UNITED STATES PATENT AND TRADEMARK OFFICE

APPLICATION NO.	FILING DATE	FIRST NAMED INVENTOR	ATTORNEY DOCKET NO.	CONFIRMATION NO.
10/791,997	03/02/2004	Daniel J. Coster	APL1P290/P3186	4300
22434	7590	05/03/2005	EXAMINER	
BEYER WEAVER & THOMAS LLP			PAPE, ZACHARY	
P.O. BOX 70250			ART UNIT	
OAKLAND, CA 94612-0250			PAPER NUMBER	
			2835

Office Action Summary

DETAILED ACTION

**Fig 1**

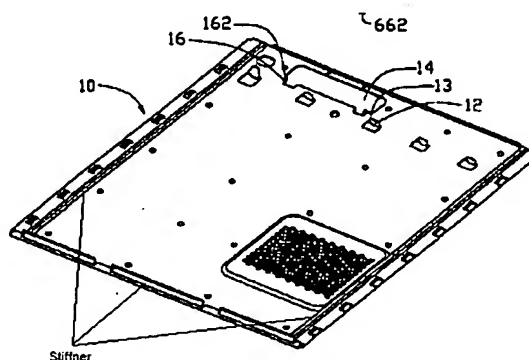
With respect to claim 38, Gan et al. further teaches the use of a stiffener (See present office action Fig 1 below) that is attached to an inner surface of the planar access door, the stiffener being configured for insertion into a recess within the access opening when the access door covers the access opening.

Fig 2

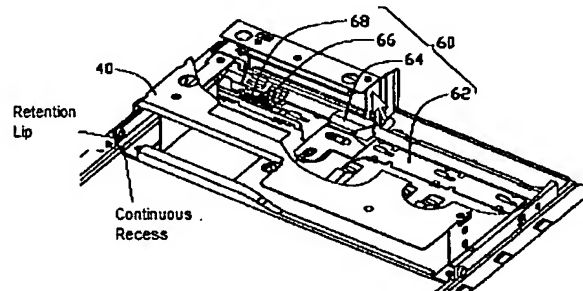
With respect to claim 40, Gan et al. further teaches the use of a computer, comprising: a housing (Comprising 10, 30) having an access opening (defined by the four walls and covered by 10) and a continuous recess (For which flange around 10 mates; see present office action Fig 2) at the edge of the access opening; a removable

access door (10) for tool-less placement in front of the access opening in order to prevent passage through the access opening (As illustrated in Fig 1), the removable access door including a plurality of hook receivers (12, 13) positioned on an inner surface of the access door (10), and a continuous retention lip for insertion into the recess of the housing (Flange around perimeter of 10 as illustrated in present office action fig 2), the engagement of the retention lip and the recess allowing the removable access door to be rotated into the access opening (Access door could be rotated by placing for example one end of the access door into the slot and rotating the top member of the door to a mating position with the housing member 30); a quick release latching mechanism (40, 62, 64, 68) for securing the access door to the housing and for releasing the access door from the housing (Column 3, Lines 36-46), the quick release latching mechanism comprising, a slider assembly (62) having a slider bar (62) that is slidably retained to the housing, and a plurality of retention hooks (624) that are attached to the slider bar and located within the access opening (The access opening is defined by the space below hood (10) where, as illustrated in Fig 5, the retention hooks (624) are located), each of the retention hooks including a flange (By the definition of flange, the hooks (624) are a flange) that is configured to capture corresponding hook receivers (12, 13) of the access door when the slider bar is slid into an engaged position, and to release corresponding hook receivers of the access door when the slider bar is slid into a disengaged position (Column 3, Lines 24-46); a handle (66) that is pivotally coupled to the housing (Via 16, and 662); a motion transform assembly (64) for transforming the rotary motion of the handle to the sliding motion of the slider bar,

the rotation of the handle in a first direction (To a flush position as illustrated in Gan; Fig 1) causing the slider bar to move from the disengaged position to the engaged position, the rotation of the handle in a second direction (downwardly) causing the slider bar to move from the engaged position to the disengaged position (Column 3, Lines 36-46).
